**CITY OF SACRAMENTO
CALIFORNIA**

ACTION OF THE PLANNING DIRECTOR

On May 20, 2004, the Planning Director approved with conditions a special permit for four house plans on 128 lots and a model home complex for the project known as Sterling Hills at Natomas Creek in the Natomas Creek PUD (P04-037). Findings of Fact and conditions of approval for the project are listed on pages 5 through 8.

Vicinity Map
P04-037
Sterling Hills
at Natomas Creek

Exhibit 6: Elevation C
(Plan 3)

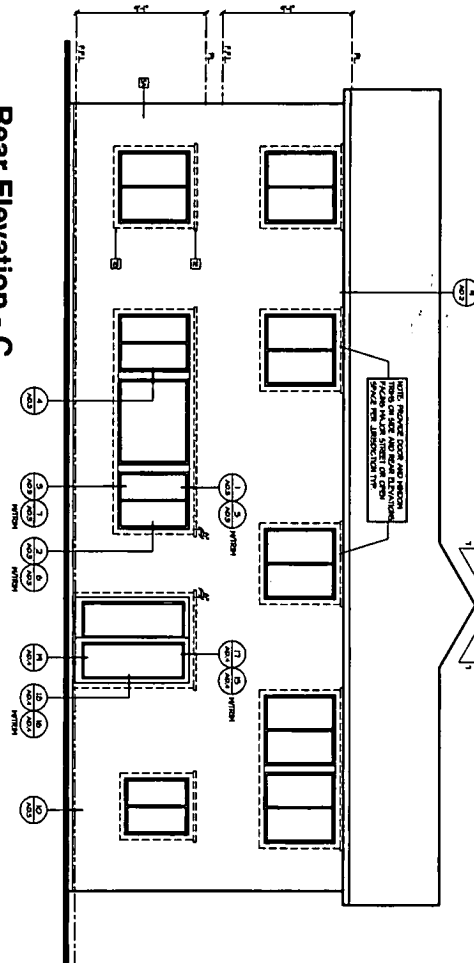
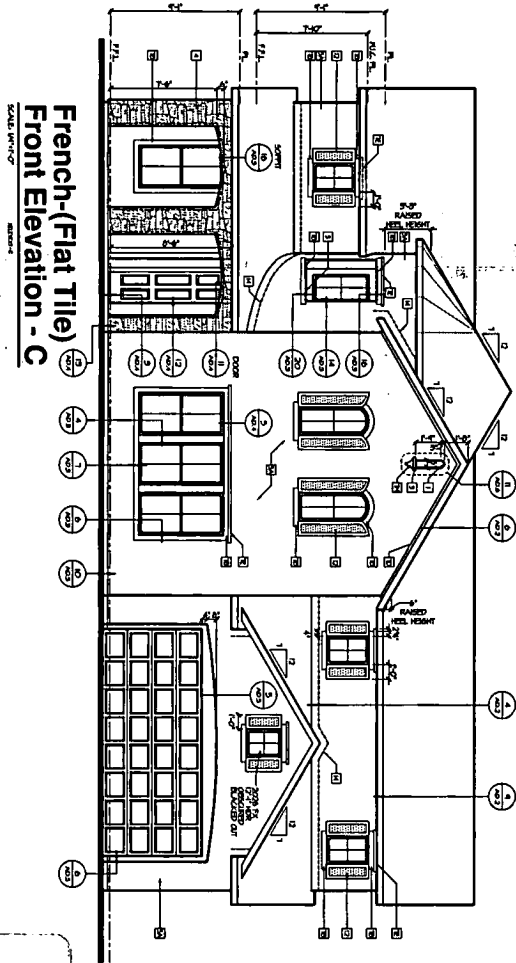
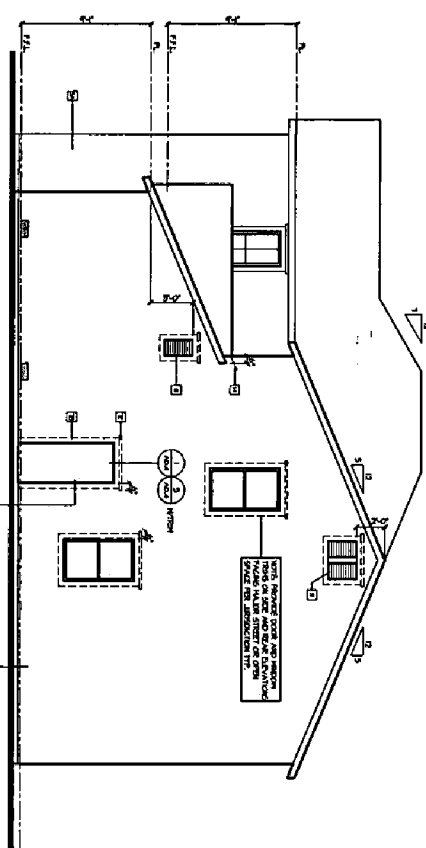
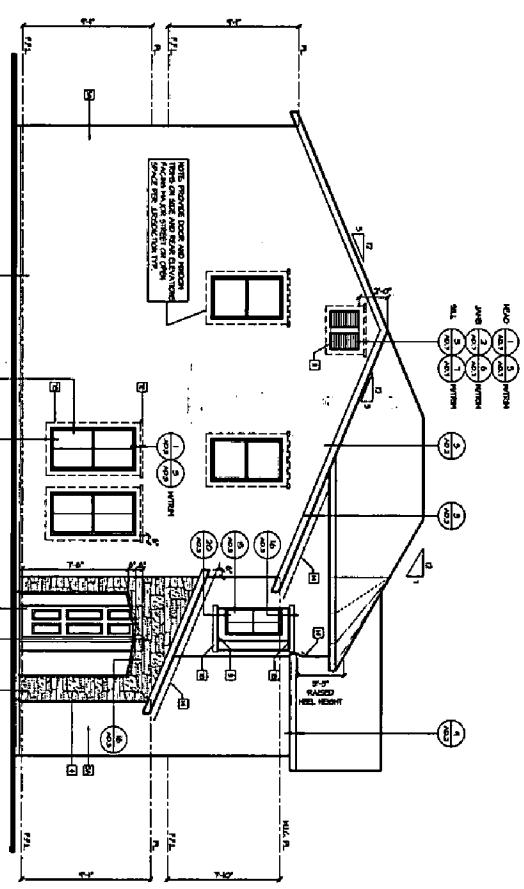
3. Both side elevations on Sterling Hills plan 3 have large expanses without architectural features. This plan should not be located on corner lots unless the elevations are improved to provide interest, e.g. add double-hung or sliding windows, clerestory windows, and under-cabinet window as needed. *Project is conditioned to provide enhanced side and rear elevations whenever either of those elevations faces a public street, school, park, canal, or other public space.*
